LOUIS ALLIS
Beloit Power Systems

U. S. Nuclear Regulatory Commission
799 Roosevelt Road
Glen Ellyn, IL 60137

Subject: Reference Telcon on 4/21/82 at 4:26 p.m.
Between Nick Jackiw of NRC and Rick Haisler,
Manager, Quality Assurance of BPS

Subject: BPS Generators Provided for Nuclear Standby Service -
Alternator to Spider Rotor Torque Value Discrepancies,
Hope Creek Alternator S/N 700510R2

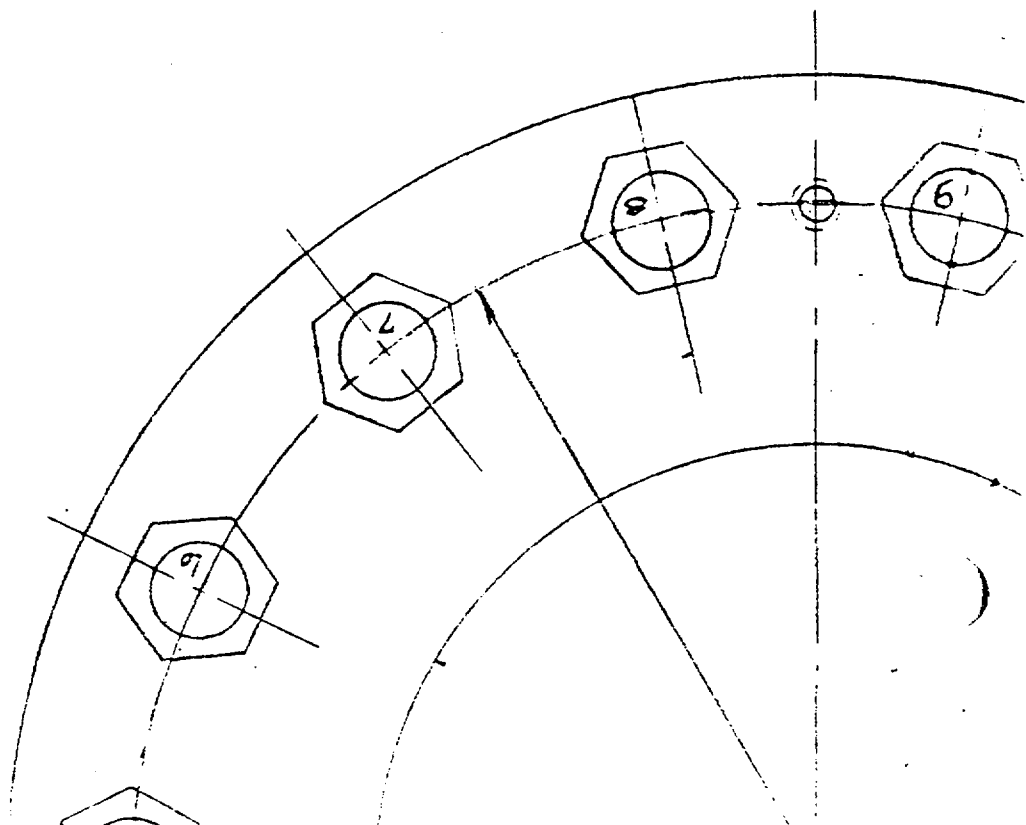
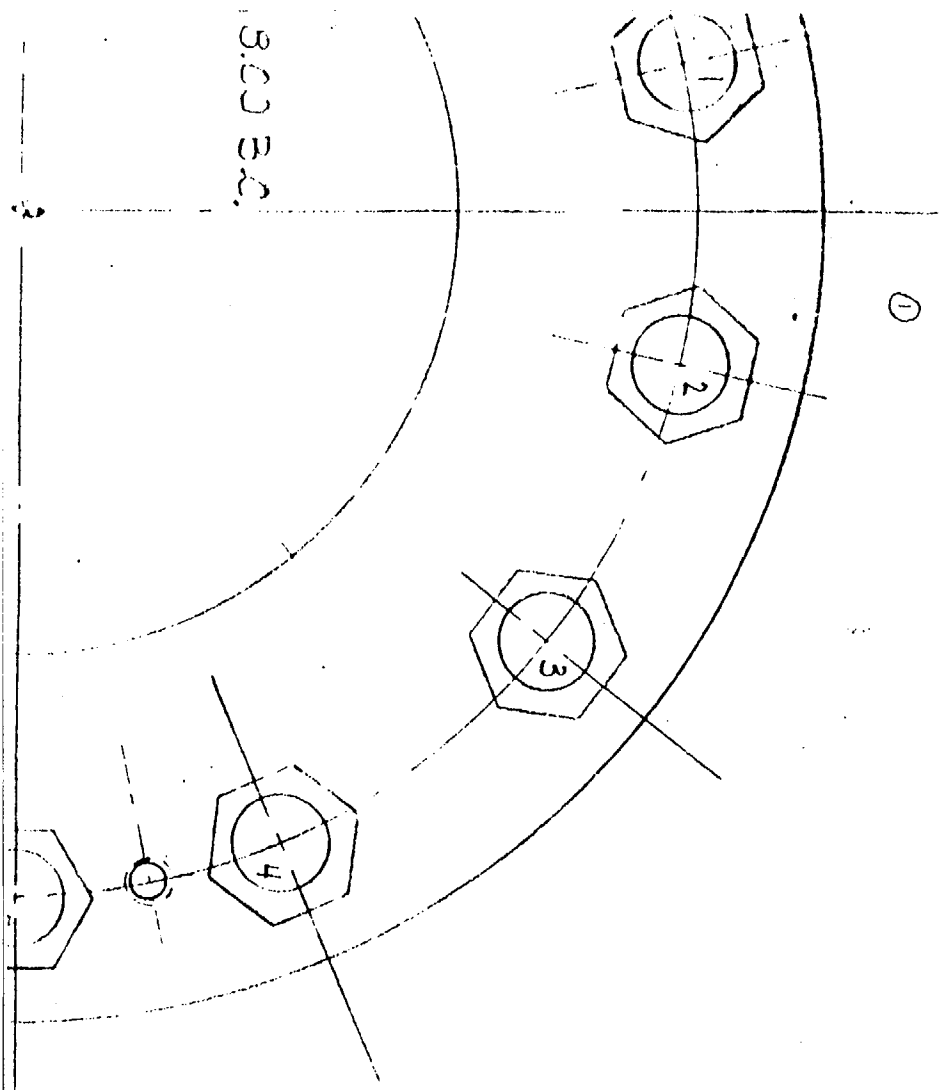
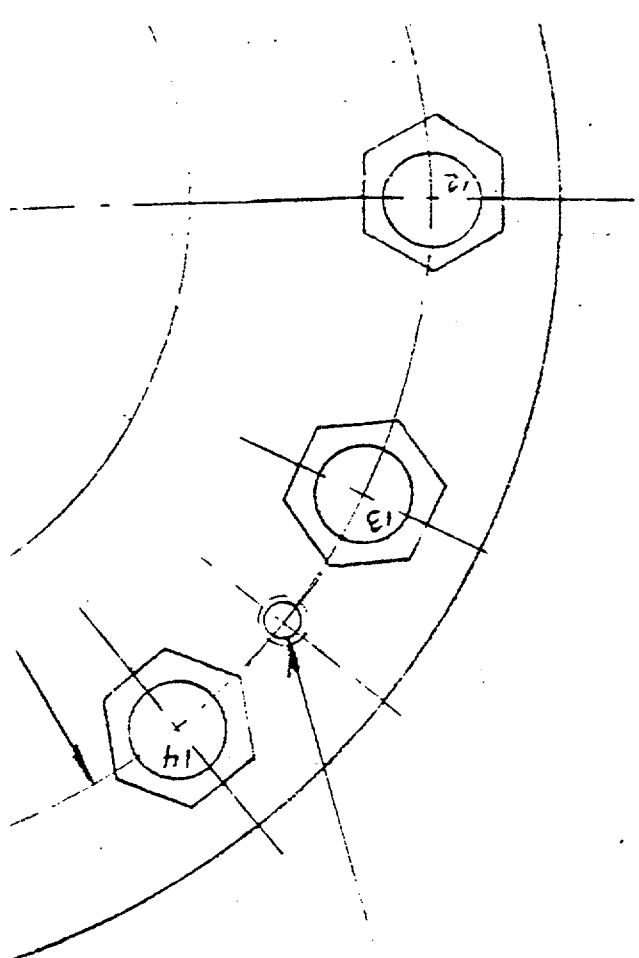
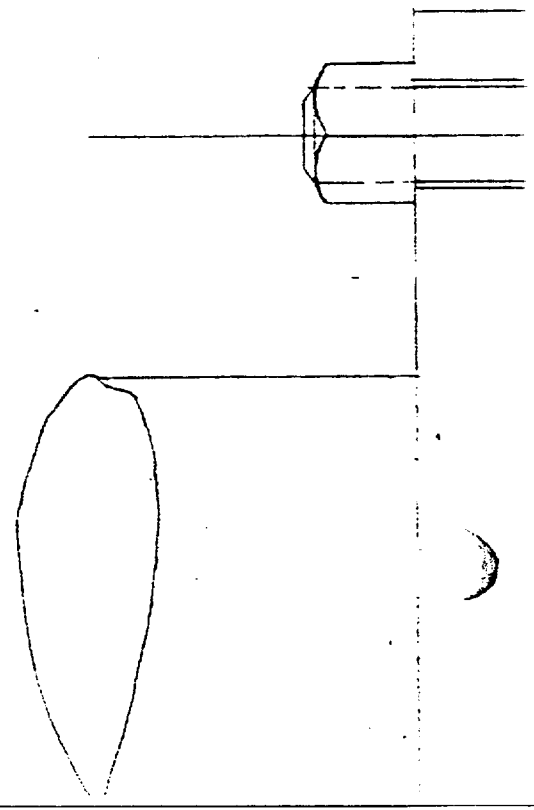
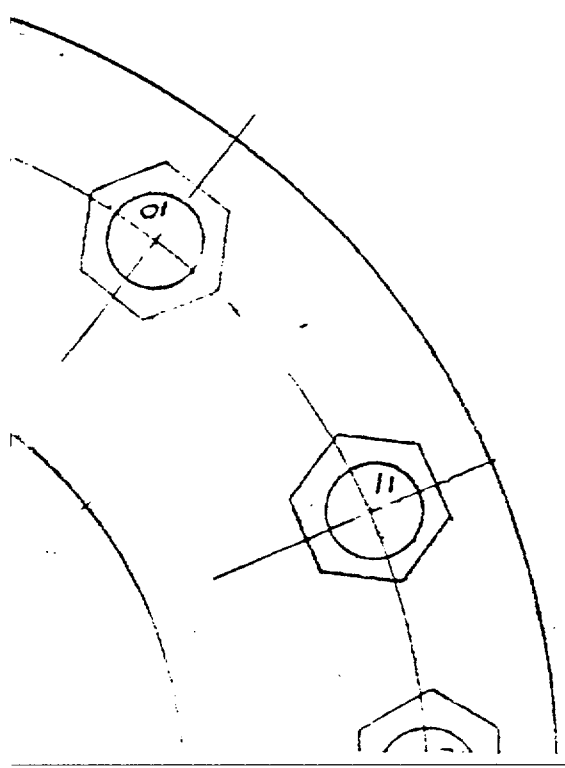
Colt performed a recheck of generator rotor to spider fastener torque values on March 12, 1982 to verify operation of newly designed tooling for use in the field. During this check, it was revealed that fastener #3 was not loaded at all while three other fasteners were only about 13% tight based on prescribed torque values. This revelation is not consistent with documentation presented to Colt, reference (b).

While estimating bolt load from the applied torque does not yield good accuracy, it is clear that the average load was not what it should have been. Even more disturbing is the one bolt that was not loaded at all and the three that were only about 13% tight. These 4 were certainly potential candidates for further loosening under operating vibration and load cycling.

The specification per 11 971 439 should have tightened all bolts to 4000 ft.lbs. Had this been true the average additional nut run-up would have been about 3/16 of one flat, only two moved this little.

STEP 4. LOCATE THE STUD NUMBERS, NUMBERED 1-14, MATCH MARK NUT FLATS TO MATING SURFACE SO AMOUNT OF MOVEMENT CAN BE DETERMINED. RETORQUE ALL NUT/STUD COMBINATIONS IN THE FOLLOWING SEQUENCE: 1, 6, 11, 2, 7, 12, 3, 8, 13, 4, 9, 14, 5, 10, AND REPEAT NUMBER 1 TO 5000PSI. MAKE

SURE NUT OPPOSITE THE NUT BEING TORQUED DOES NOT TURN DURING THE TORQUING PROCESS. RECORD AMOUNT OF NUT ROTATION.
